UPDATE #3
TO THE
TECHNICAL DRAINAGE STUDY
FOR
SUMMERLIN STORAGE
(MINI STORAGE FACILITY AT WESTCLIFF AND RAINBOW)
(APN 138-27-802-001)
IN
CITY OF LAS VEGAS, NEVADA

HORROCKS PROJECT NUMBER: NV-LD-3629-21

SUBJECT: **Update #3 to the Technical Drainage Study for Summerlin Storage (Mini Storage Facility at Westcliff and Rainbow), APN: 138-27-802-001 (DS5459H)**

FIGURE 7

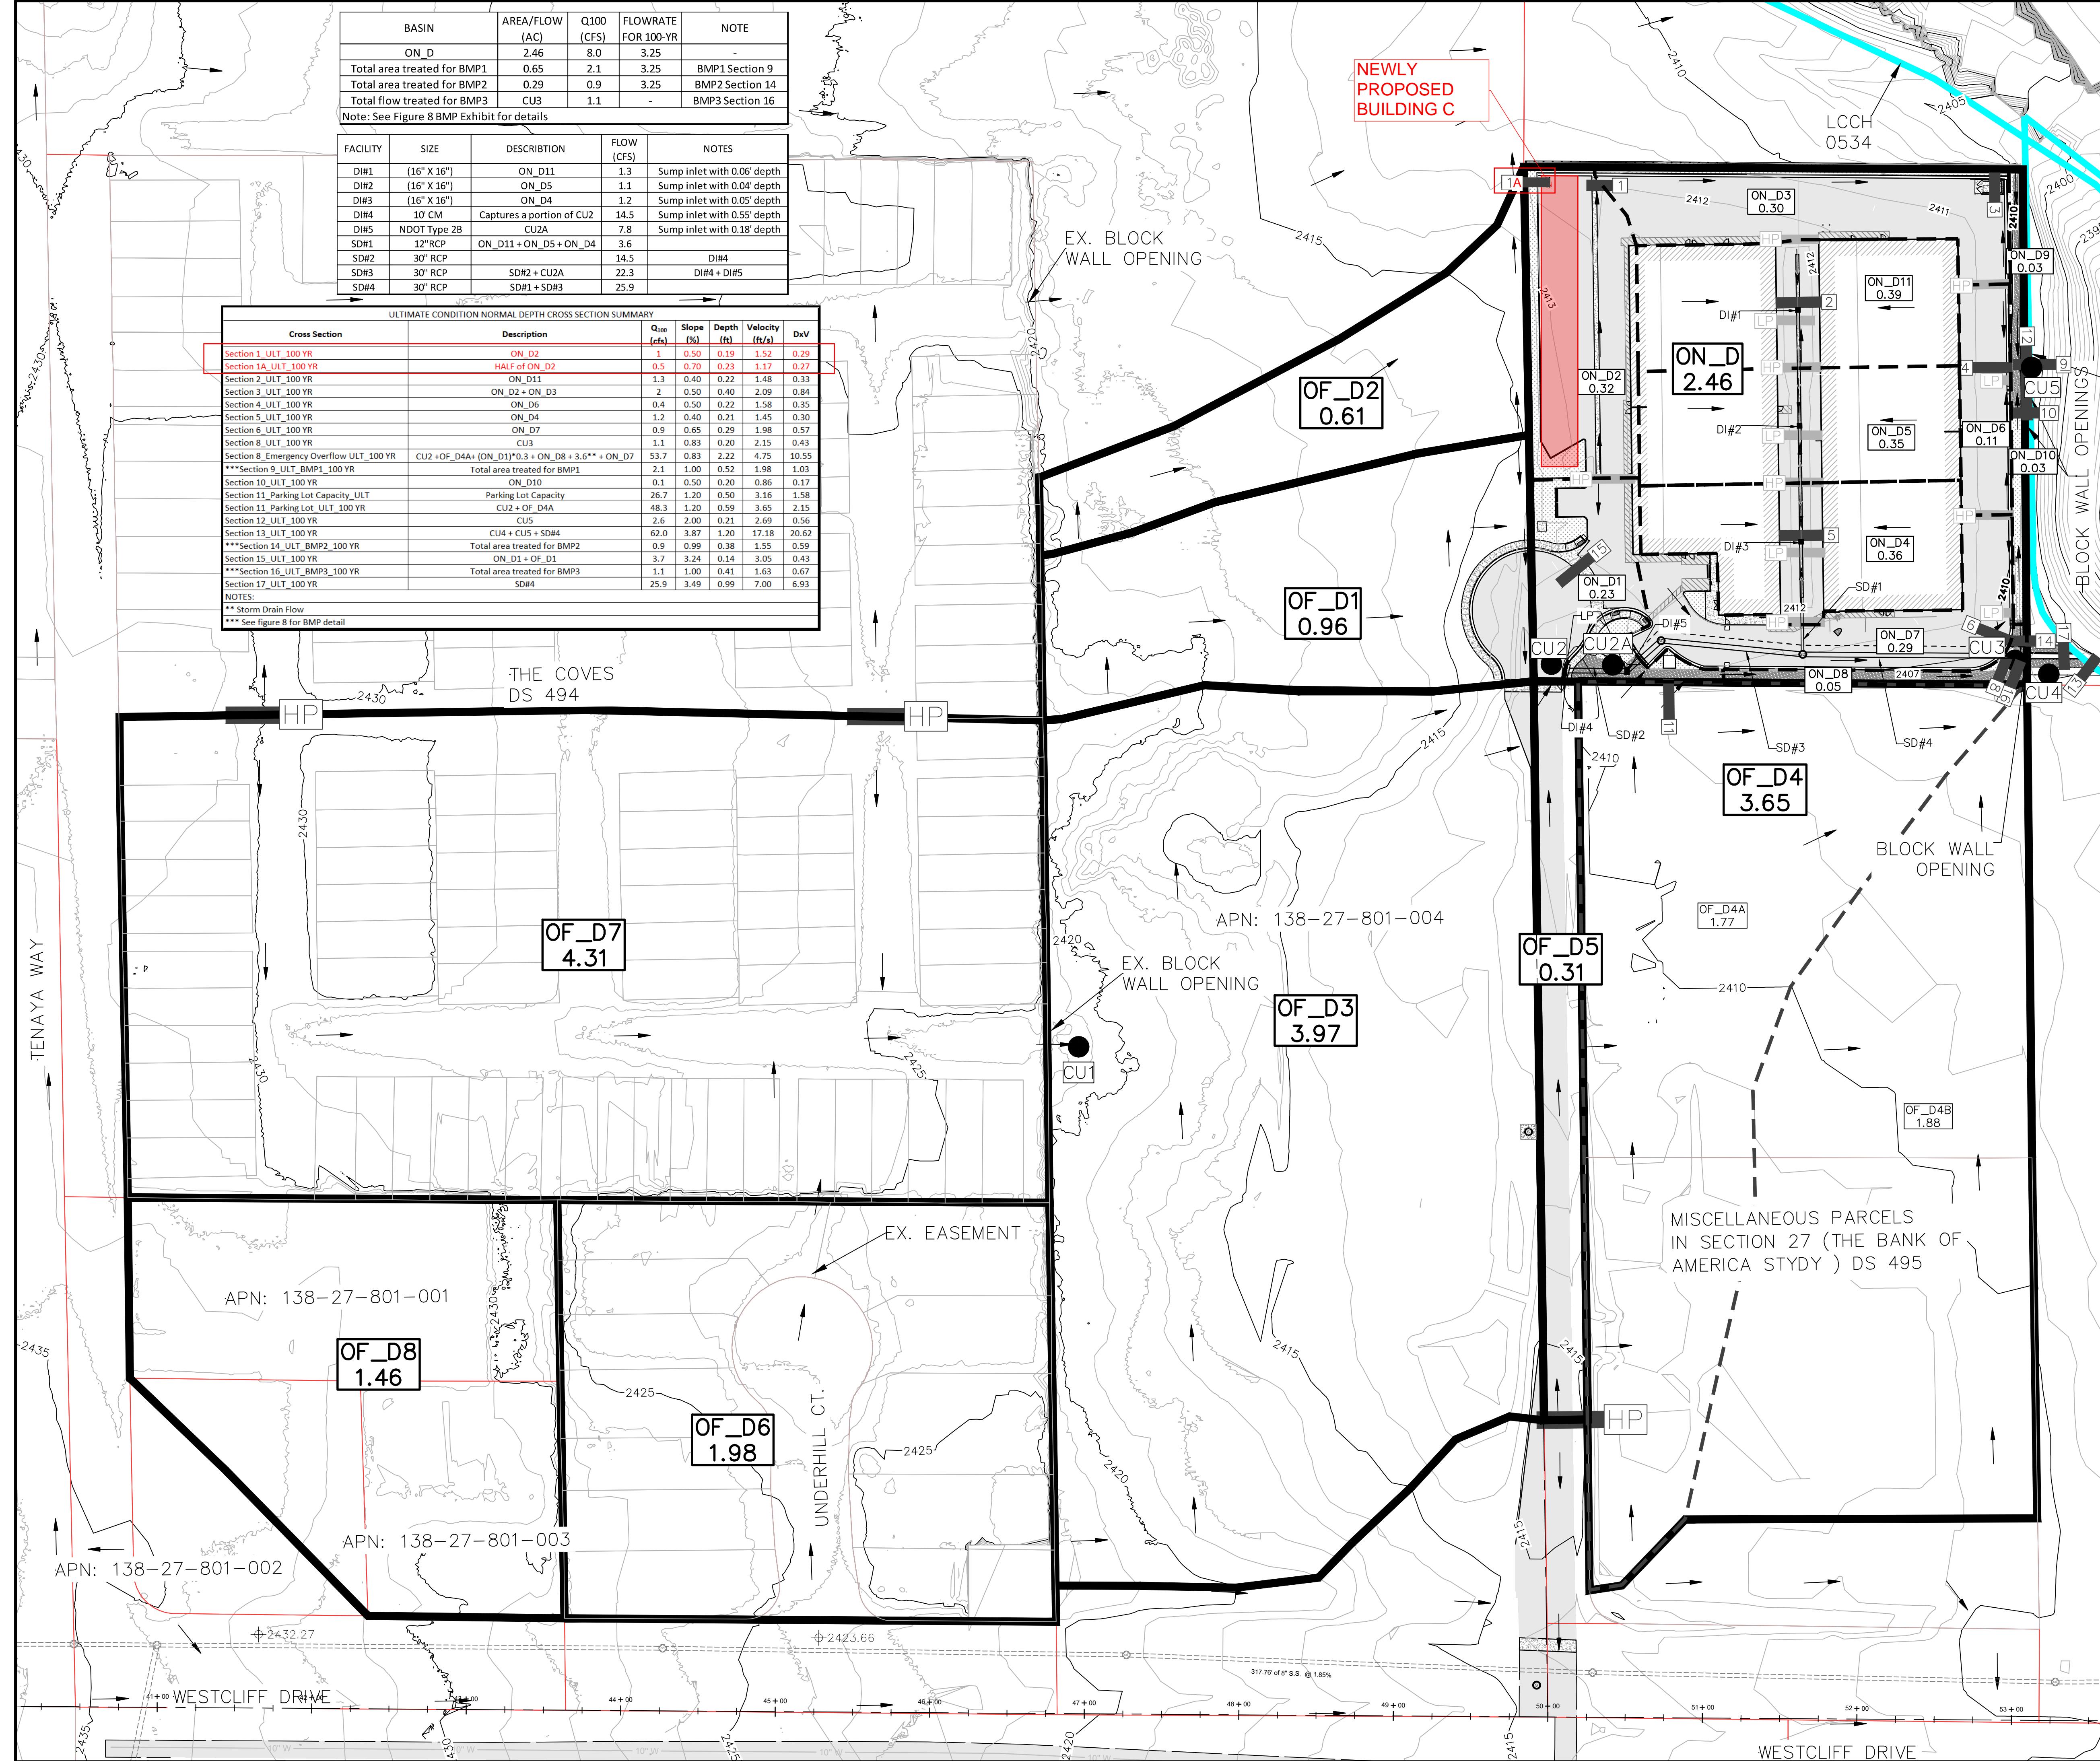
The new building meets all finished floor criteria of being at least twice the depth of flow and at least 6" above the adjacent top of curb elevations or flowlines. The flow summary and normal depth tables have been updated on Figure 7. The Finished Floor Analyses table has been updated to include Building C at six locations: the four corners of the building as well as at a midpoint on each side of the building. See the Appendix for revised Figure 7 Ultimate Condition Basin Map with the revised basin summary, and normal depth tables. The revisions are outlined in red. All pertinent hydraulic calculation can be found in the Appendix.

Section 1_INT&ULT_100 YR

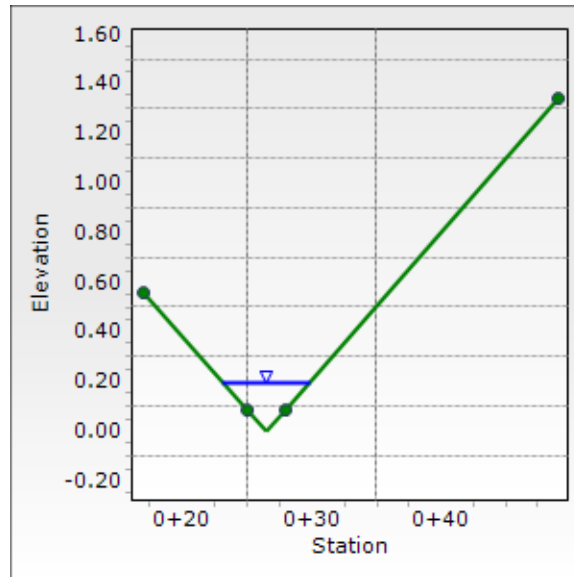
The revisions include a revised normal depth calculation for section 1 to show the new flow characteristics abased on the revised section that the building creates. Section 1A is now included and is the swale between the building and the western site boundary. Section 1 includes a 6% slope on the west side of the valley gutter. Section 1A shows a 4:1 side slope on the west side of the swale as labeled on the grading plans and uses a 5:1 on the east side of the swale. The typical section shows a 3:1 maximum, but the FF and FL labels shows a maximum side slope between 15-20%. The 20% side slope was chosen to present a realistic and conservative normal depth calculations.
